**SSPD8 - ENGINE TEMPERATURE AND HEATER PERFORMANCE CONCERNS WITH OR WITHOUT DTC P0126:00**

**Updated 3/4/2026:**

**WARRANTY EXTENSION**

REPAIR PROCEDURE – FLOW CHART

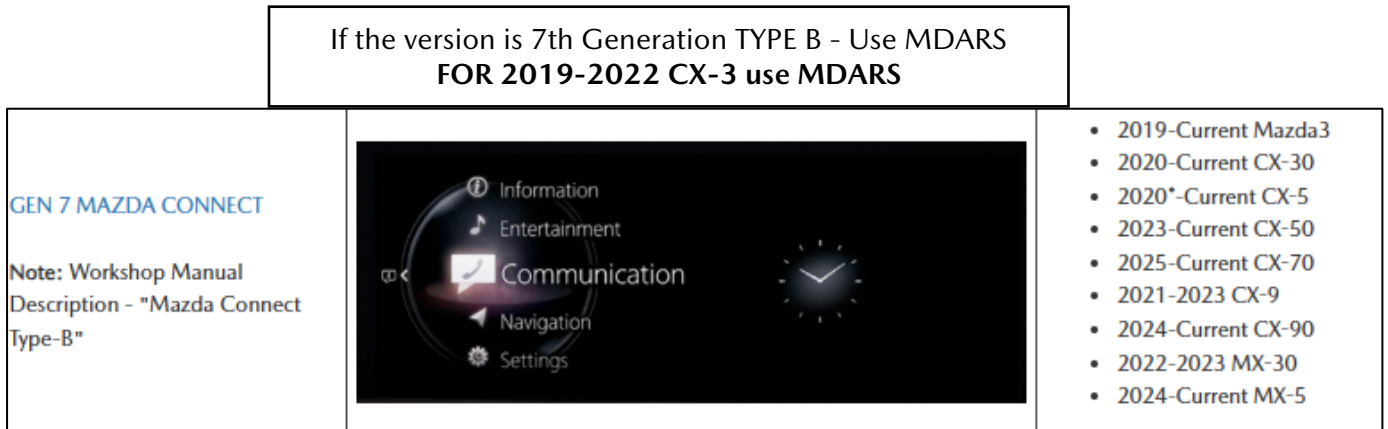
Section A: Flow Chart: **NOTE: This Flow Chart needs to be followed strictly.**

The dummy plug and PCM update repair procedure are required as of December 8, 2025. The TSB has been updated to repair with the dummy plug and PCM update here: [6](#).
